Service Letter #: SL18 66-47200

66-47201 Side, Left, Hydraulic Pedestal

66-47400 Rudder Retract Handle

Float Model Affected: New product serial numbers: 6650 Float Serials 158-159 and following. Existing product serial numbers: 6650 Float Serials 156-157 and previous.

Side Left, Hydraulic Pedestal 66-47201

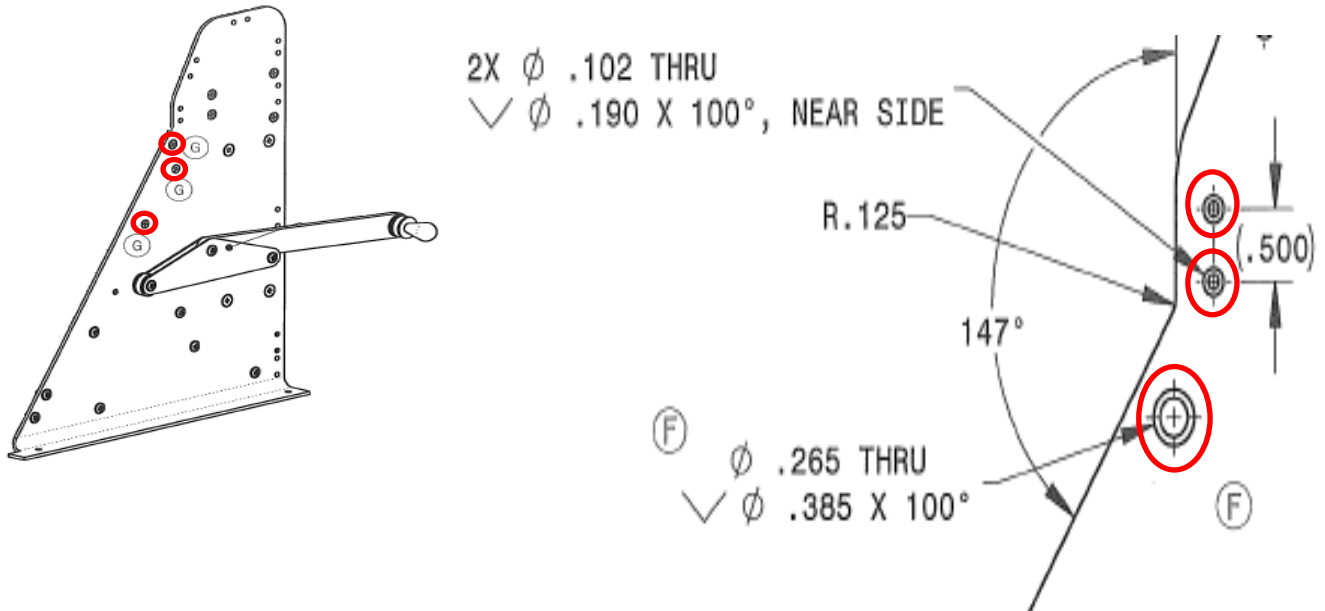
Symptom: Existing fasteners causing cosmetic scratches on arm of rudder retract handle and pedestal side.

1. Apply countersink to thru holes as shown

2. De-bur and apply chemical conversion coating to bare surfaces, Use Alodine 1132 Touch 'N Prep Pen or Alodine 1201.
3. Replace AN525 washer head screws with MS24694 flathead screws at 3 locations on left side.

Corrective Action: Replace washer head screws with countersunk type screws.

Part 66-47400 - Rudder Retract Handle:

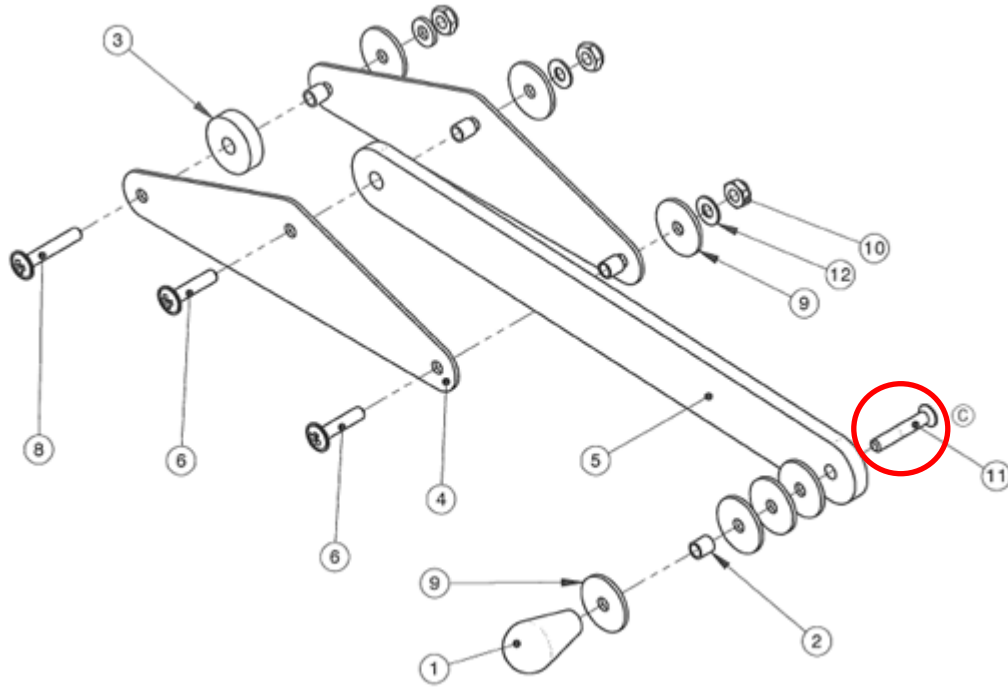
Replace washer-head screw on rudder retract handle with flathead screw.
